Number: TSB-FC-2015-003

Symptom: Exhaust wraps smoking on CS7000

CS7000 (Gasoline & LP Models), Haram Captor II

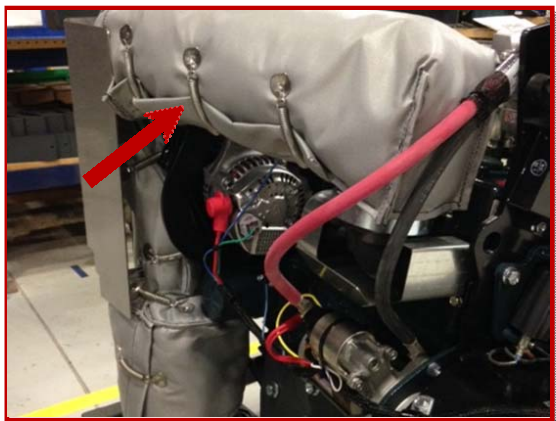
Exhaust wraps may deteriorate over time, allowing debris to contact hot exhaust components and possibly cause smoking.

Exhaust wraps are deteriorating under high heat conditions. Seams may open and trap debris that can create smoke or a burning smell

Existing wraps with wire or spring fasteners

New wrap has snaps

Implementing a new exhaust wrap with a higher heat rating and improved closures

Inspect existing wraps in the field. If they are loose, open, or missing any components, replace with the new exhaust wraps. Be sure to inspect exhaust wraps regularly for debris that may be collecting in and around the seams and clean if necessary.
